REQUEST

Current Zoning: R-3 (single family residential)
Proposed Zoning: R-8MF(CD) (multi-family residential, conditional)

SUMMARY OF PETITION

**STAFF
RECOMMENDATION**

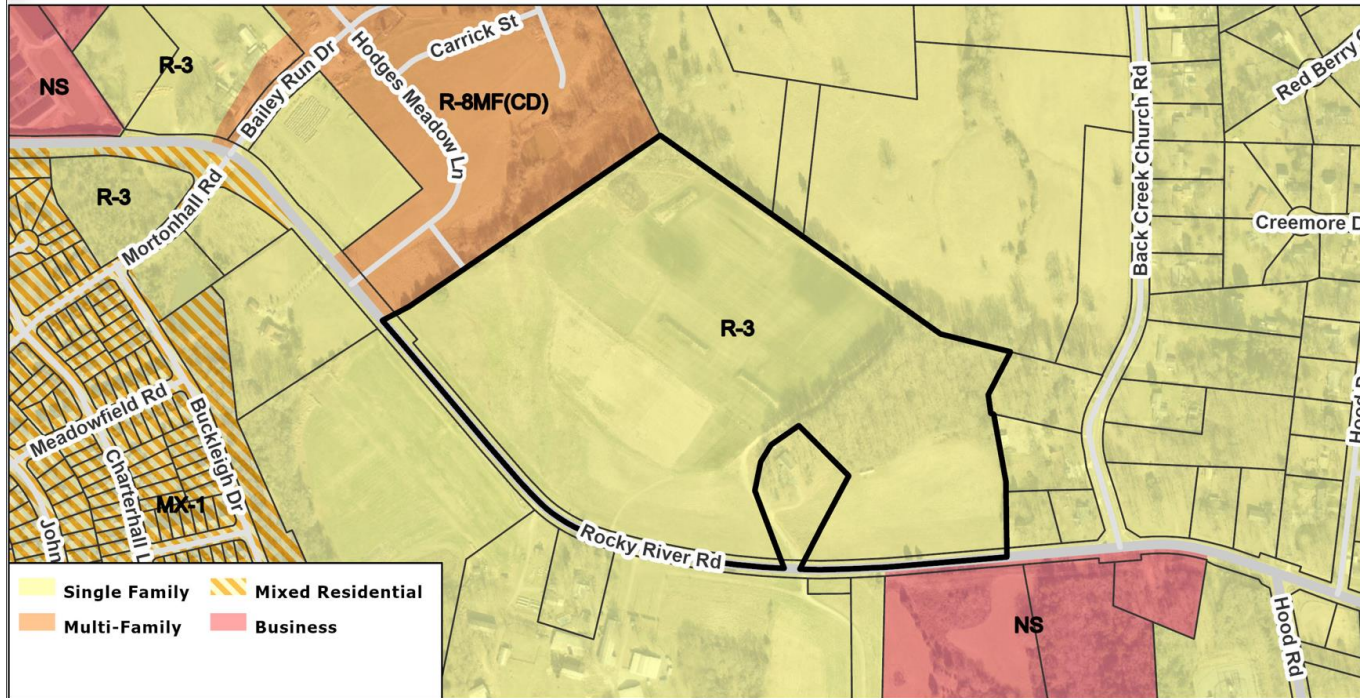
1. 4-foot Median is to be constructed on Rocky River Road. Label, dimension, and commit to proposed median. Addressed

2. The proposed berm shall be removed from the park dedication area. Addressed
3. The note needs to be revised to state that the 1.5 acres proposed park shall be dedicated and conveyed to Mecklenburg County for a future neighborhood park. Addressed
4. The site data table shows 15% tree save but there is not 15% show on the plans. Site is located in a wedge so a min of 15% of the overall site is required to be shown as tree save. Addressed

5. Specify if townhomes are to be "land for sale". Addressed
6. Add townhomes to proposed use. Addressed
7. Add to site data table: density allowed, density proposed, number of units allowed, number of units proposed. Addressed

8. Future Eastern Circumferential Road. Because of the road type setback should be discussed with staff.
9. Show and label required side and rear yards based on building orientation. This applies to the overall property boundaries not the sublots. Addressed

21. Development Data Table references the 50-foot Class C buffer, but not the 30-foot Class C buffer provided adjacent multi-family. Not addressed
22. **New comment resulting from revised site plan dated 5/18/2023:** Previous site plans submitted state total 38.25 acres, while most recent plan states 42.46 acres. Please confirm which acreage is correct.

23. New comment resulting from revised site plan dated 5/18/2023: Add to Site Data Table – "15 ft. setback per Section 9.303(19)(f) of the zoning ordinance. Not addressed
